## ST. TAMMANY PARISH

**Addendum No:** 2

**Bid No:** 416-21-17-70-2

**Project Name:** Riverwood Subdivision and Covington Country Club  
Estates Drainage Improvements – Phase 1

SHEET NUMBER <b>9</b>	ST. TAMMANY	DESIGNED D.N.H.	PROJECT H.011458
		PARISH	STATE
ADDED NOTES AND REVISED DETAIL	REVISION DESCRIPTION	DATE	NO.
DMH			
02/27/18			
28.AUG.17			
D.N.H.			
D.M.S.			
FEDERAL			
PROJECT

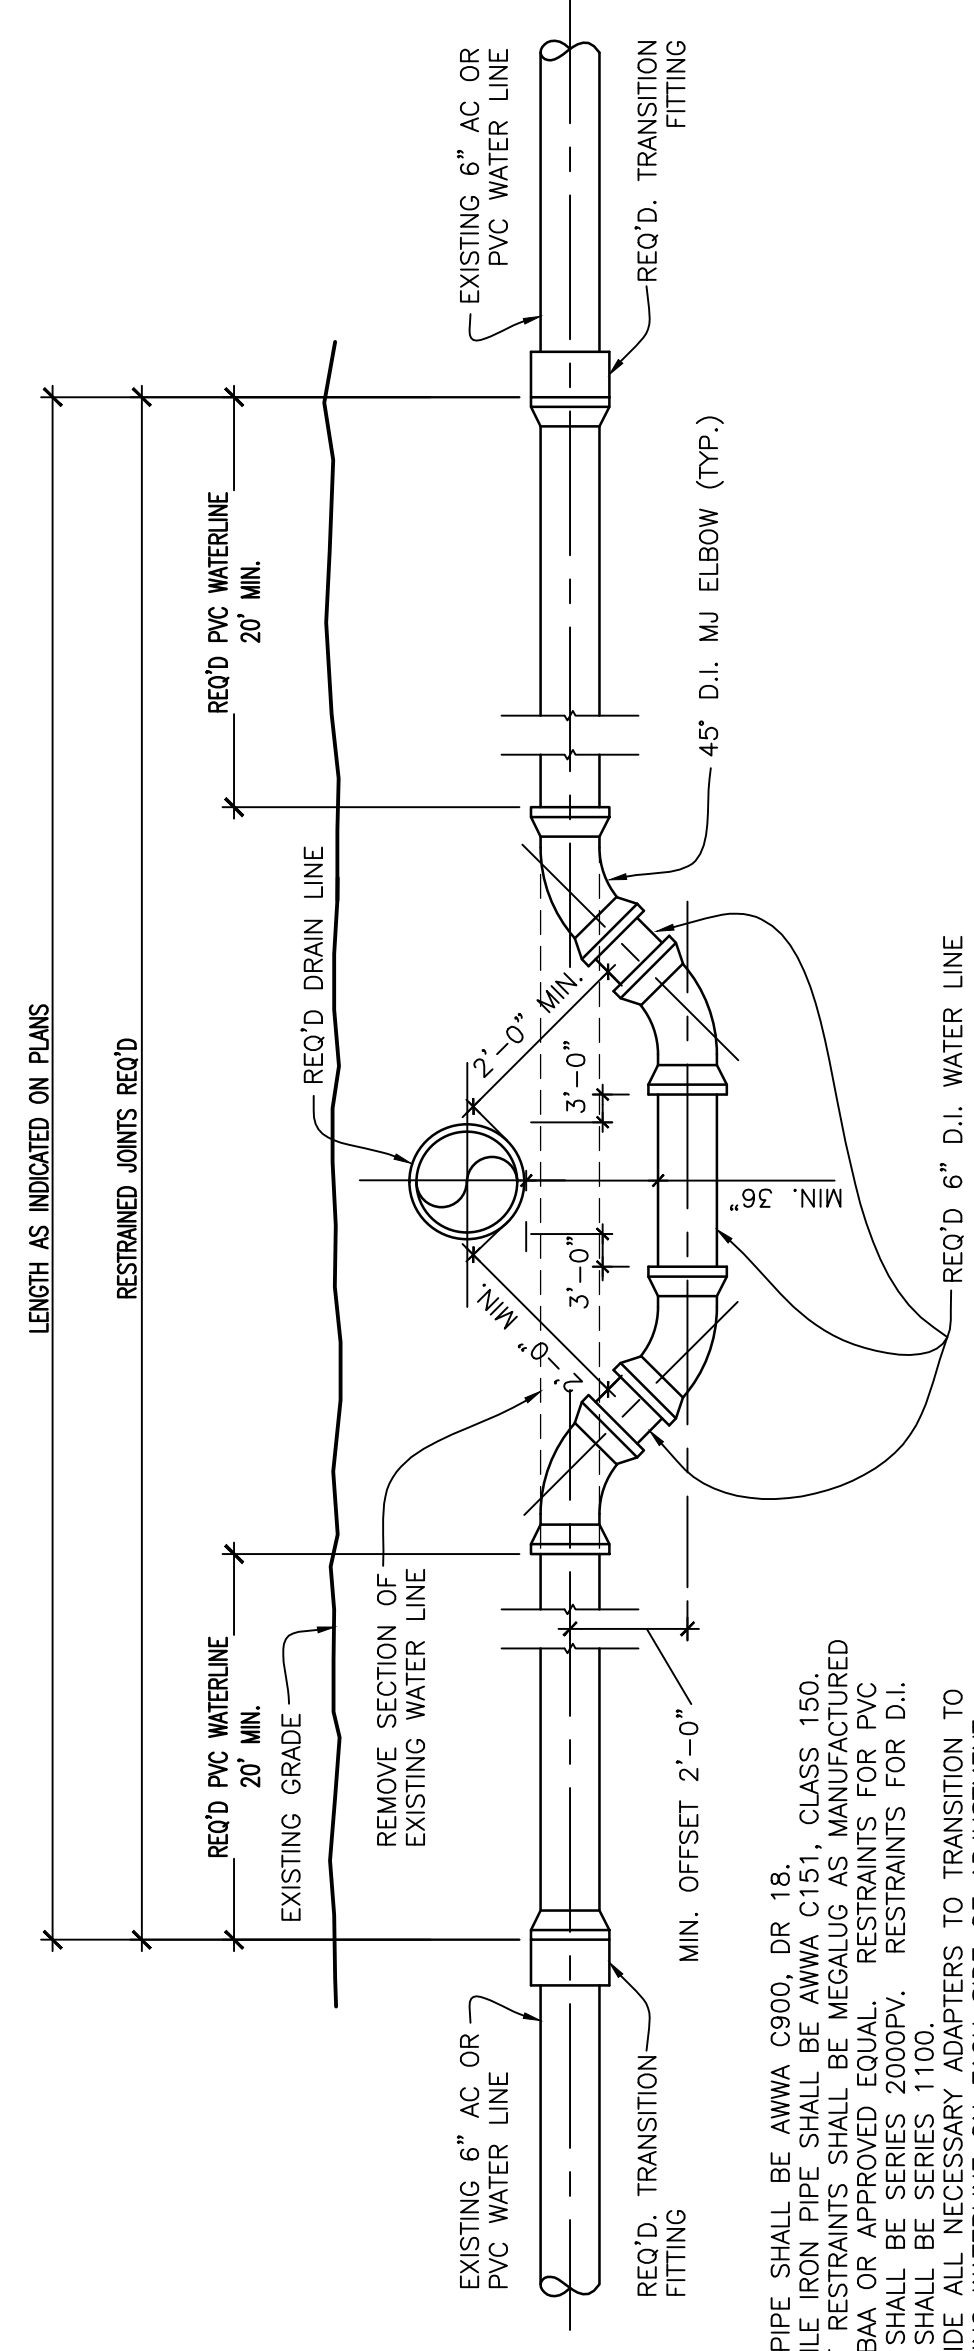
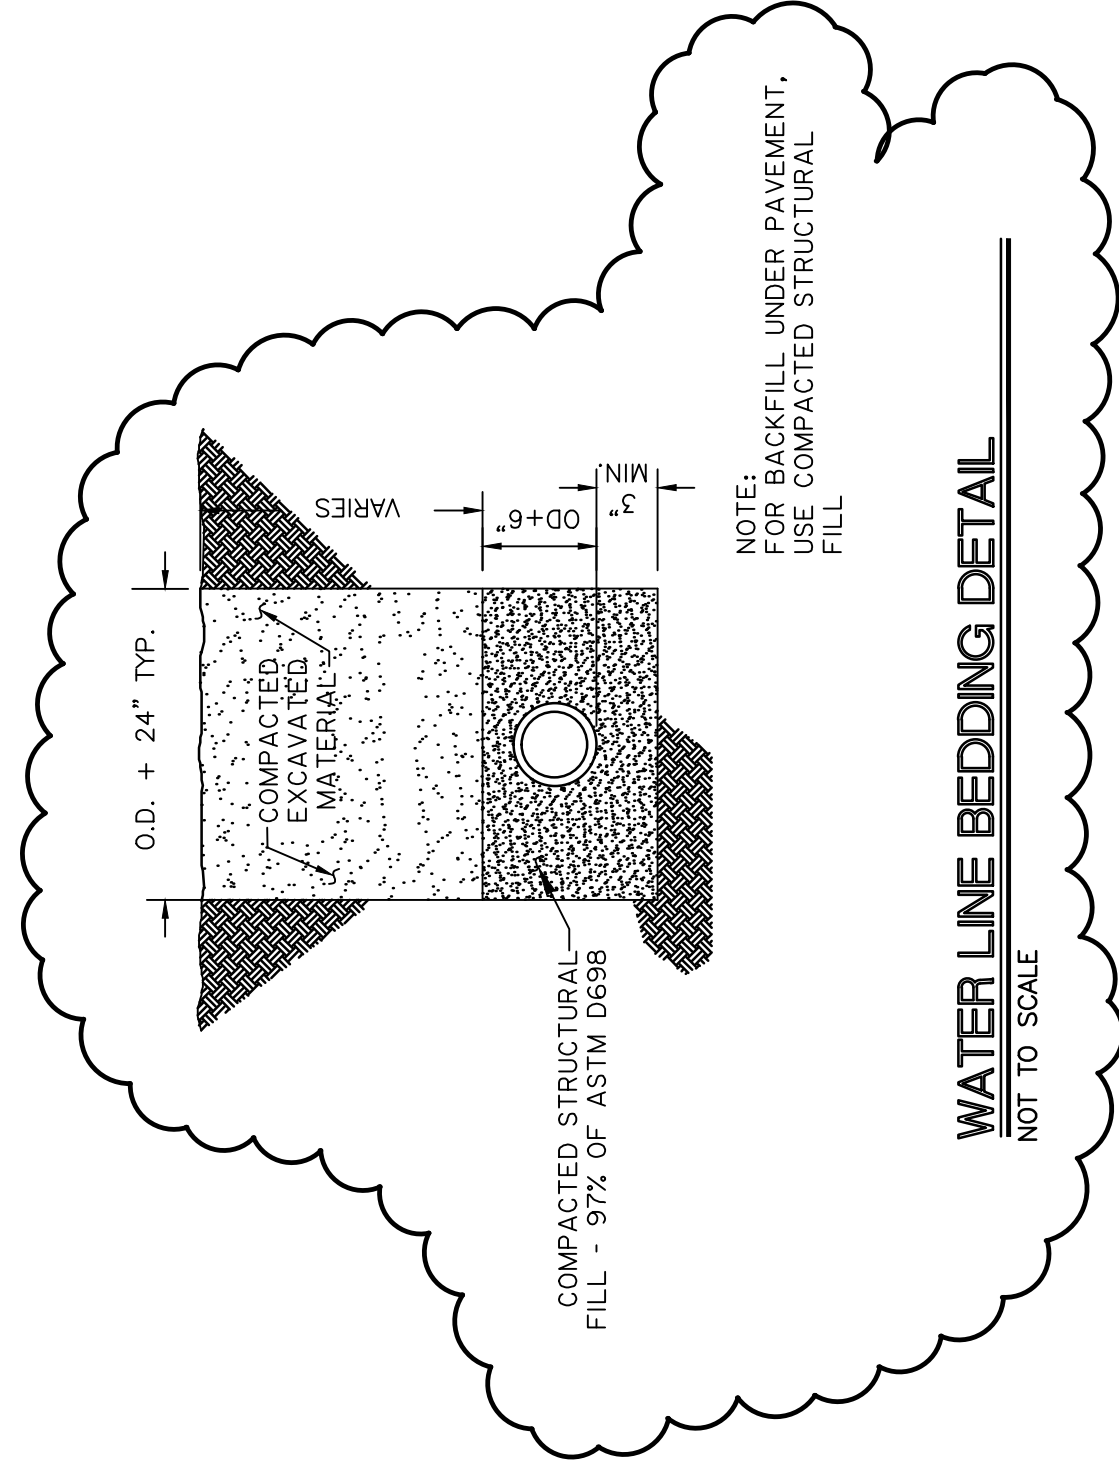
- 6. Please remove Plan Sheet 3 and replace with Plan Sheet 3 - Revised (attached).**
- 7. Please remove Plan Sheet 9 and replace with Plan Sheet 9 - Revised (attached).**

- Question #16:** The pipe bedding detail on Plan Sheet 9 appears to be in conflict with other bedding details in the plans. Please clarify.
- Answer #16:** The pipe bedding detail on Plan Sheet 9 was intended for use on water line work. The name of this detail has been changed to WATER LINE BEDDING DETAIL on Plan Sheet 9 – Revised (attached).

**WATER LINE BEDDING DETAIL**  
 NOT TO SCALE
